SB Number:	SB PF-016	Creation Date: 04/02/2009
Subject:	Paper conveying failure may occur	
Model:	PF-750

Affected models: FS-9130DN/9530DN

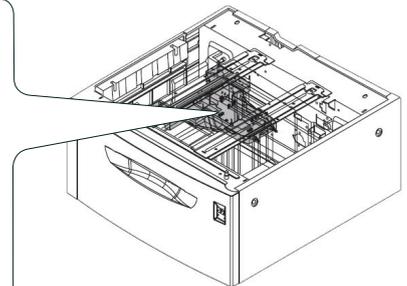
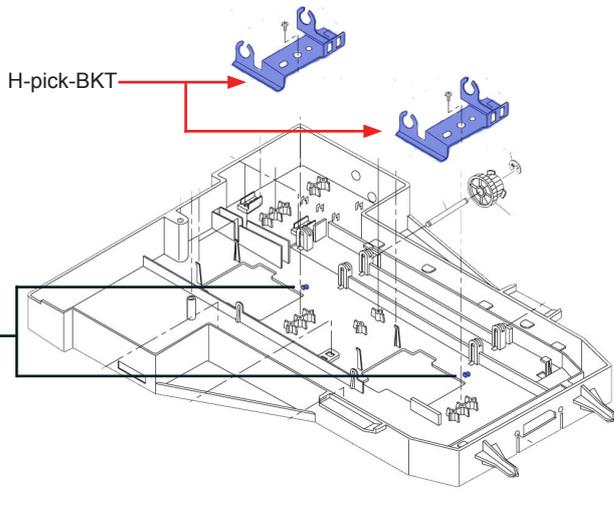
Cause	The hooks for the H-pick-BKT at the H-conveying base brake off, so that the H-pick-BKT 305A707361 loosens.
--------------	--

Solution	<p>The following changes have been made to the hook at the H-conveying base:</p> <ol style="list-style-type: none"> 1. The width has been changed from 4mm to 8mm. 2. 2 ribs have been added. 3. The curve of the hook shape has been rounded.
-----------------	---

Close up of the hooks for the H-pick-BKT

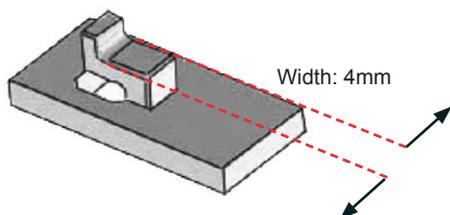
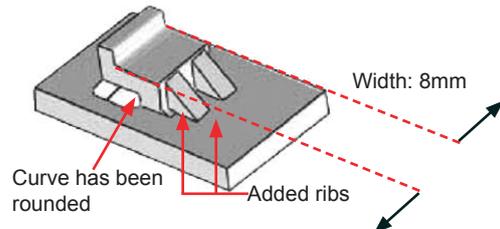
Phenomenon; Hooks of the H-pick-BKT at the H-conveying base brake off, so that the H-pick-BKT loosens.

Old condition of the hook

New condition of the hook
